Determination 2017/072

Dispute about the compliance of the ventilation system and the installation of kitchen appliances to a café kitchen at 387 Tamaki Drive, St Heliers, Auckland

B1: The PS1 'Producer statement – Design review' (page 2), and the drawing of the kitchen ventilation that accompanied the PS1.

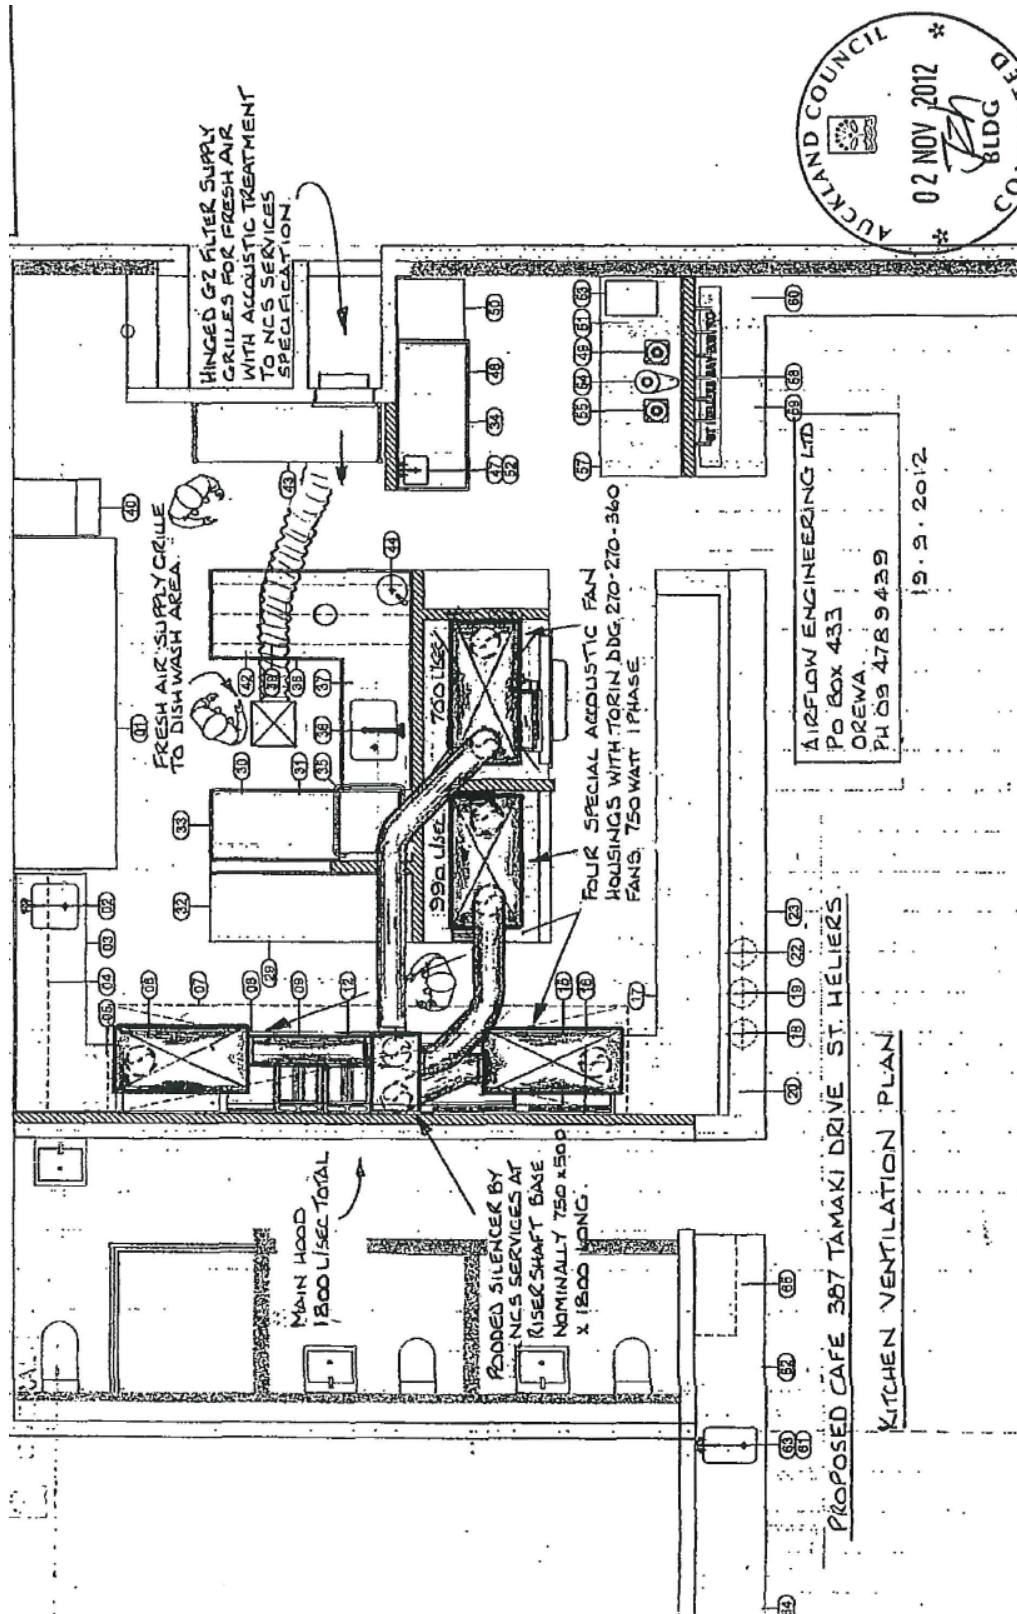
- 5.2.6 The applicant refers to the drawing accompanying the PS1 to support the view that the consent included solid fuel appliances saying that this ‘clearly shows that the gas fuelled and solid fuel appliances are combined into a single duct riser’. It is noted that the drawing accompanying the PS1 (refer Appendix B) shows single ducts running from each of the four extract hoods to the exhaust riser; no separate duct is shown to the chargrill hood. It is not known why a separate duct was not provided.

- 5.6.1 The PS1 stated ‘fresh air to be provided at rear of full height louvered plenum by means of vertical row of hinged filter grilles to suit.’ In my view, the make-up air as shown in the drawing accompanying the PS1 submitted with the building consent (dated 19 September 2012) with the full height supply air inlet and air enclosure described in paragraph 2.4.2 may have provided an adequate supply, but the drawing does not provide a detailed description of what was intended to be built. Opinions between the applicant and the tenant vary significantly as to what the drawing accompanying the PS1 showed was to be installed.

- 5.6.2 The air plenum shown in the drawing accompanying the PS1 was enclosed behind an internal wall as part of the original building consent, and kitchen equipment is located where the air enclosure containing filters and sound attenuation is shown. The building consent failed to specify the means by which adequate make-up air was to be supplied to the kitchen.

- 6.1.1 The PS1 makes specific reference to the make-up air (‘fresh air to kitchen’) being supplied via a full height louvre that may have been adequate; the louvre is shown on the drawing accompanying the PS1 as being connected to an air enclosure providing filters and acoustic attenuation. The consented drawings show a solid wall in this location and the equipment list that formed part of the approved consent also shows items in front of this wall in the same location as the air enclosure.

Expert	<ul style="list-style-type: none"> The PS1 says 'Fresh air to be provided at rear of full height louvered plenum by means of vertical row of hinged filter grilles to suit.' It was unclear whether the grilles mentioned are connected to the duct shown on the drawing accompanying the PS1, an implied separate supply or both. It is reasonable to expect the PS1 note would apply to both the ducted fresh air to the dishwasher area, and the separate make-up air supply. 'The wall of the outdoor-air plenum on the kitchen side was completely sealed, with the only opening present for the [approximately 300 x 300 grille to the dishwasher area]'. The grille over the dishwasher area was providing 'some of the required make-up air'. 'The as-built make-up air would appear to contradict the intentions of the designer to supply a separate outdoor-air supply from the single duct and grille. It is difficult to ascertain the level of deviation from the intended design as the details provided are minimal.' The outdoor air supply system is shown on the kitchen ventilation plan drawing, but no specifications for the flow rate is given and indicates the make-up air is for the café seating area only not for the kitchen extract system. The expert concluded that as no details of either a mechanical or passive make-up air system for the extract system has been provided it is unlikely the make-up air to the kitchen extract system meets AS 1668.2.
